# Stage 2.3 The Dardanelles - SECTION 96

THIS PLAN TO BE READ IN  
CONJUNCTION WITH  
MOD2012/0242  
WARRINGAH COUNCIL

PROJECT  
STAGE: 2.3 DARDANELLES  
CONSTRUCTION OF 14  
INDEPENDENT LIVING UNITS  
@ 'THE DARDANELLES'  
RSL ANZAC VILLAGE, NARRABEEN

SHEET TITLE:  
PROPOSED STAGE 2.3  
FIRST FLOOR SITE PLAN  
SECTION 96 ISSUE

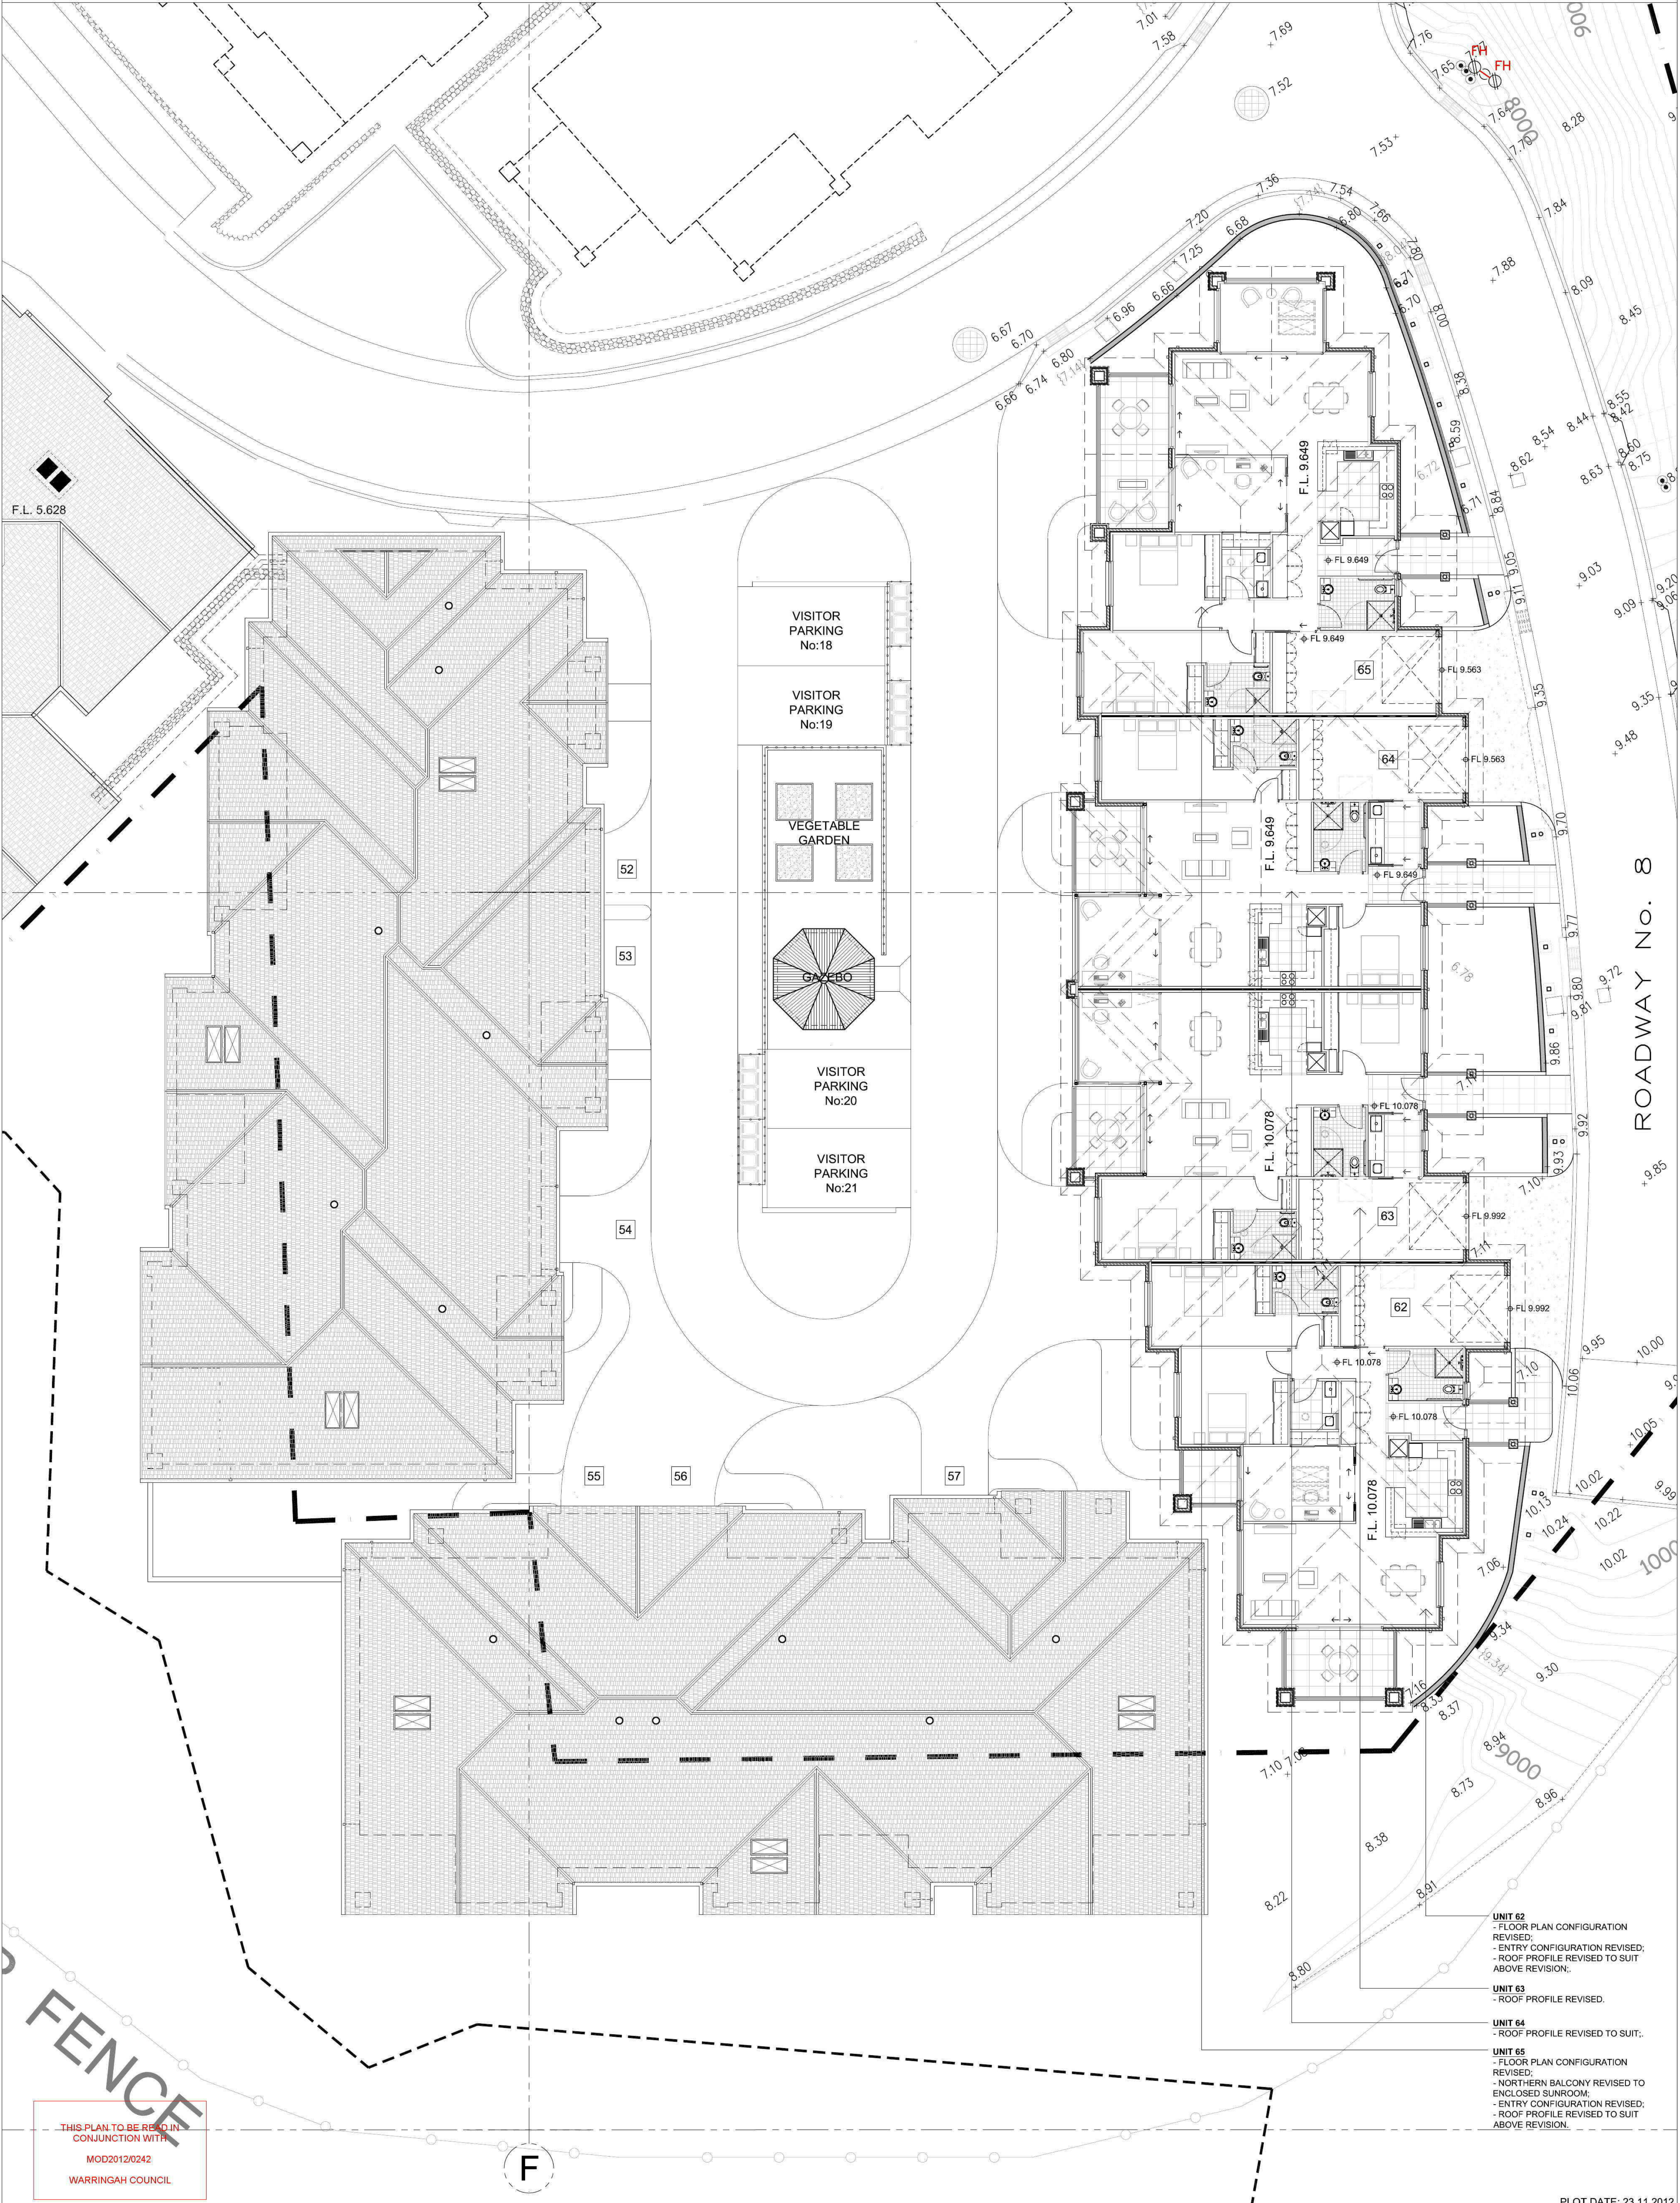
- UNIT 62**  
- FLOOR PLAN CONFIGURATION REVISED;  
- ENTRY CONFIGURATION REVISED;  
- ROOF PROFILE REVISED TO SUIT ABOVE REVISION;
- UNIT 63**  
- ROOF PROFILE REVISED.
- UNIT 64**  
- ROOF PROFILE REVISED TO SUIT;
- UNIT 65**  
- FLOOR PLAN CONFIGURATION REVISED;  
- NORTHERN BALCONY REVISED TO ENCLOSED SUNROOM;  
- ENTRY CONFIGURATION REVISED;  
- ROOF PROFILE REVISED TO SUIT ABOVE REVISION.
